Response to United States Environmental Protection Agency's comments dated January 17, 2014 for the Teledyne Semiconductor/Spectra-Physics Superfund Sites *Work Plan Addendum for Vapor Intrusion Evaluation of Residential Buildings in the Off-Property Study Area*, 1300 Terra Bella Avenue and 1250 Middlefield Road, Mountain View, California dated January 8, 2014

Work Plan Addendum for Vapor Intrusion Evaluation of Residential Buildings in the Off-Property Study Area, 1300 Terra Bella Avenue and 1250 Middlefield Road, Mountain View, California

**FIGURE 3**

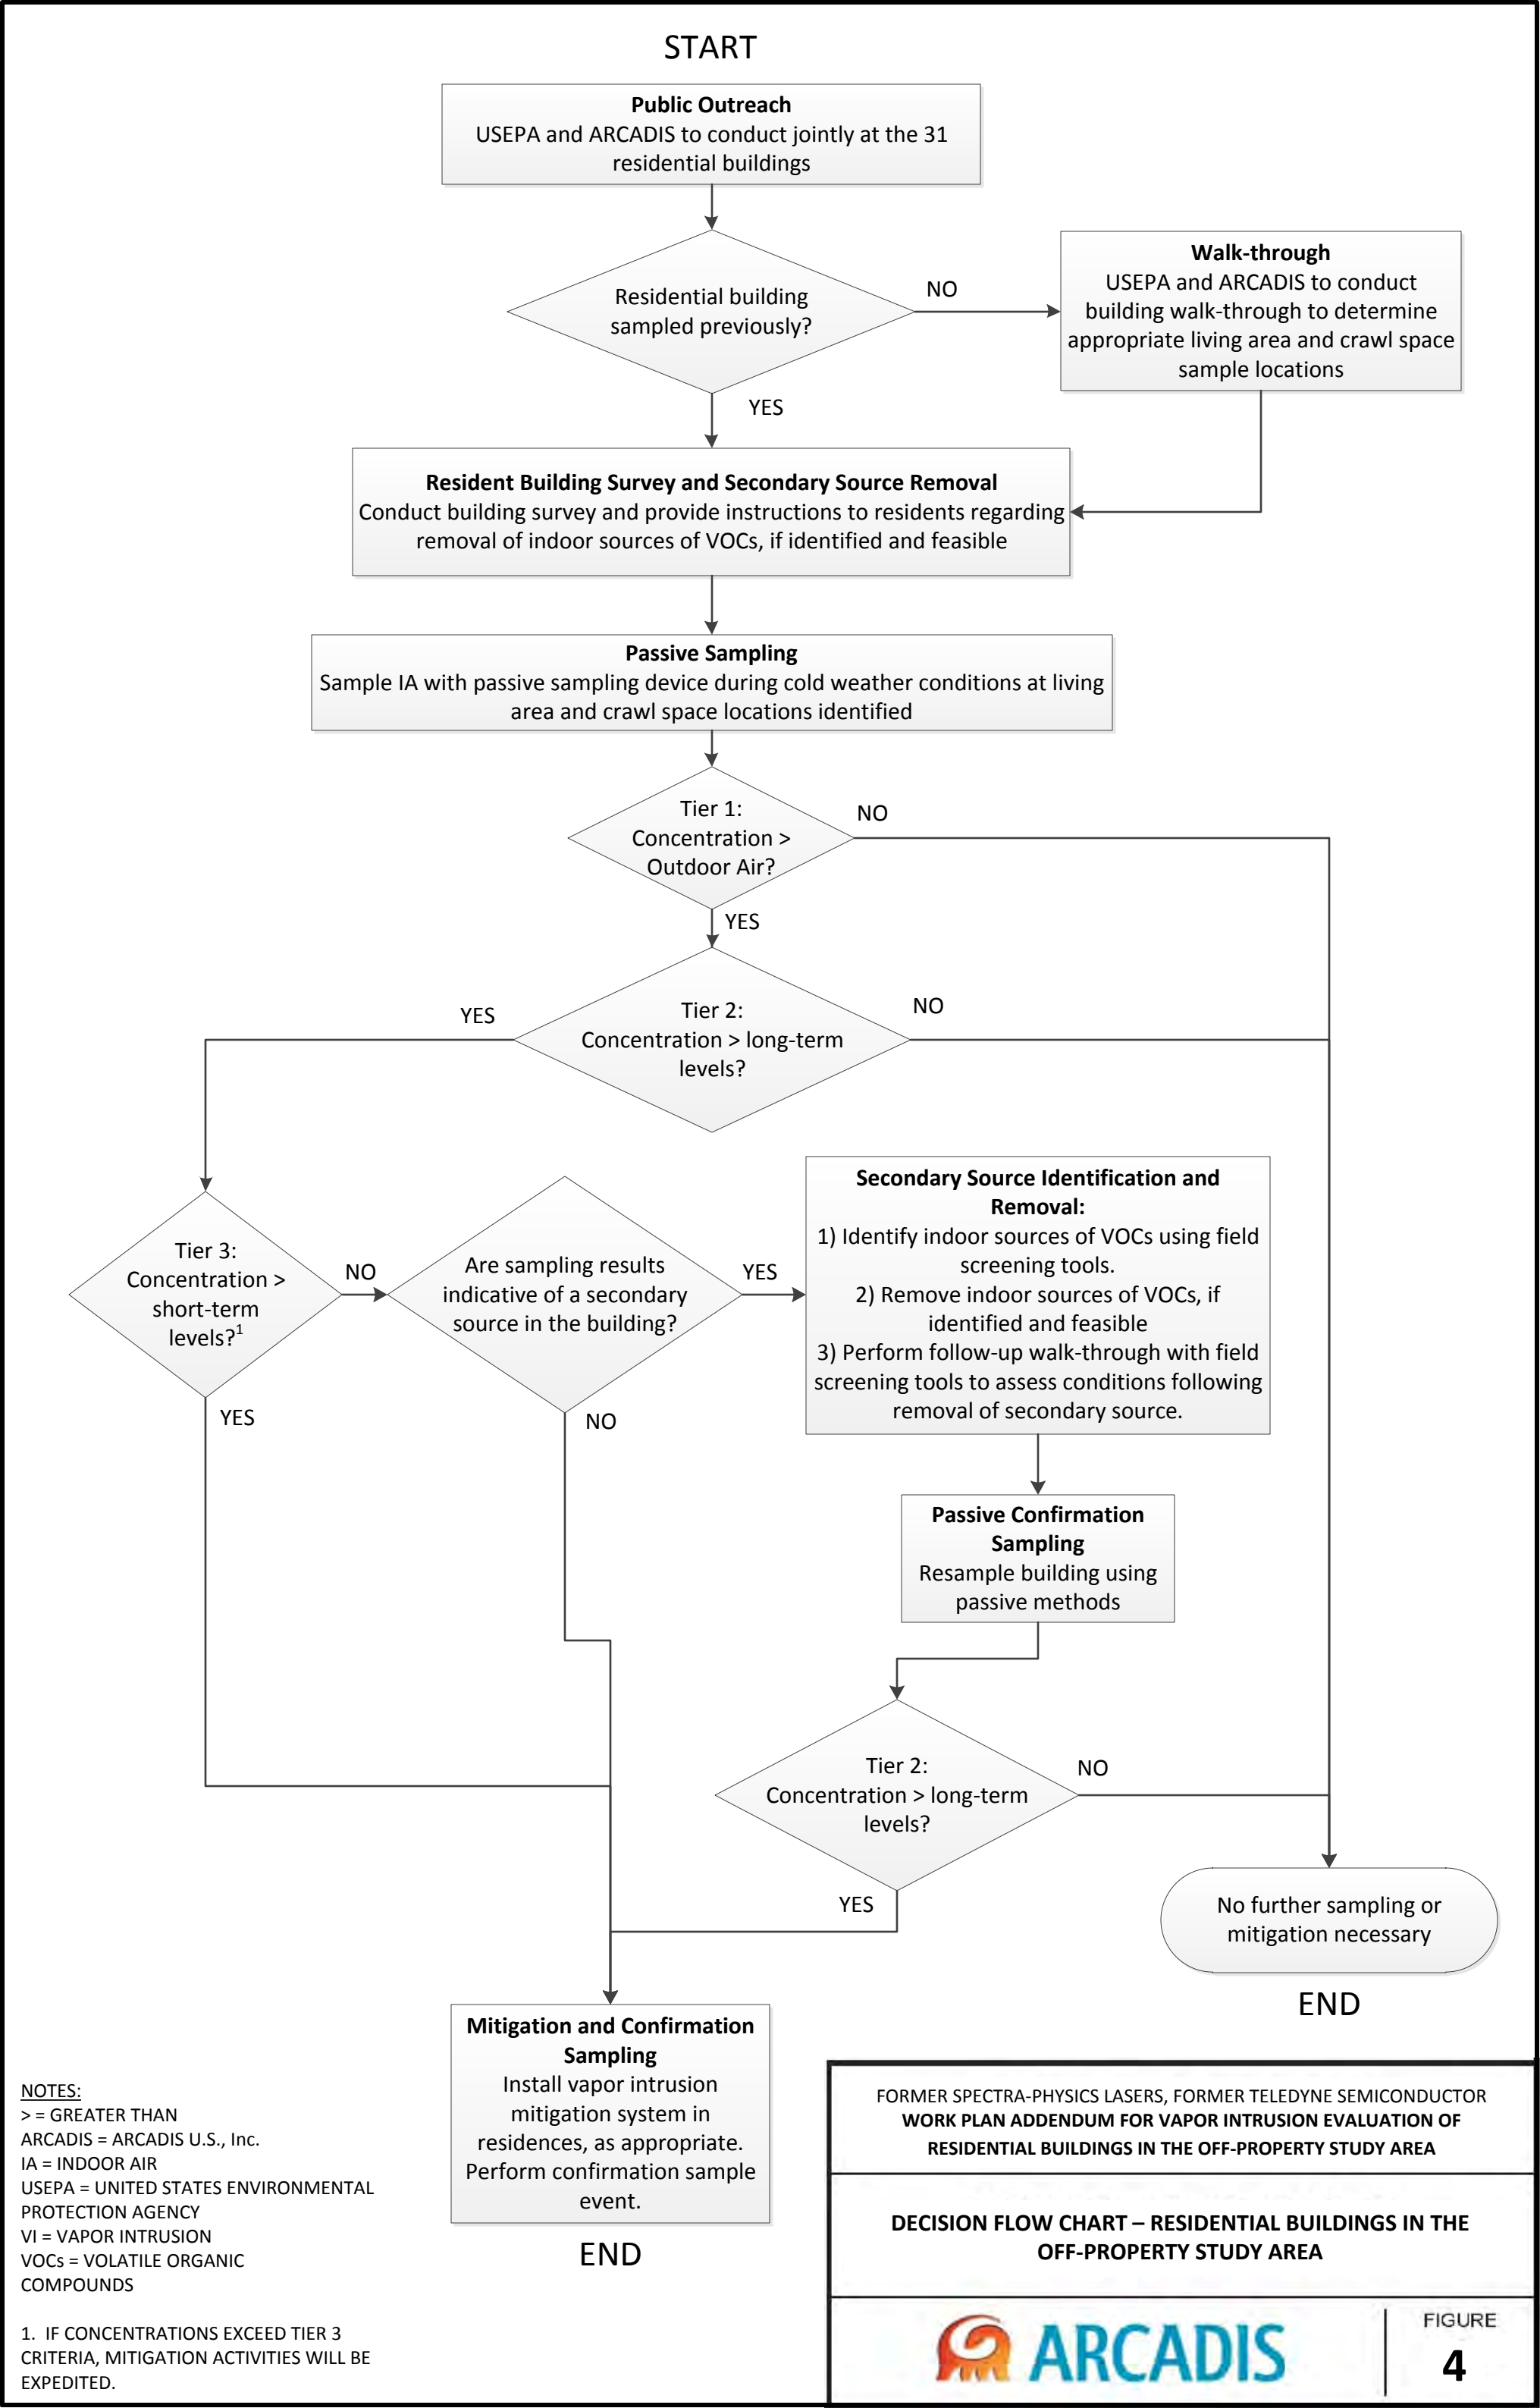
**As we have discussed, the implementation of the successful enhanced reductive dechlorination (ERD) remedy has substantially decreased groundwater-trichloroethene (TCE) levels at former Teledyne property. The Addendum would benefit from a figure that shows the residential study area (currently Figure 2) set against the most recent post-ERD shallow-zone groundwater-TCE contours (currently Figure 3).**

Agreed. Please see attached Figure 2-REV (Attachment 2). The figure presents November 2009 contours as presented in the 2010 Work Plan (ARCADIS 2010) and November 2013 50  $\mu\text{g/L}$  TCE contours, and highlights the 32 residential buildings included in the residential building vapor intrusion study area.
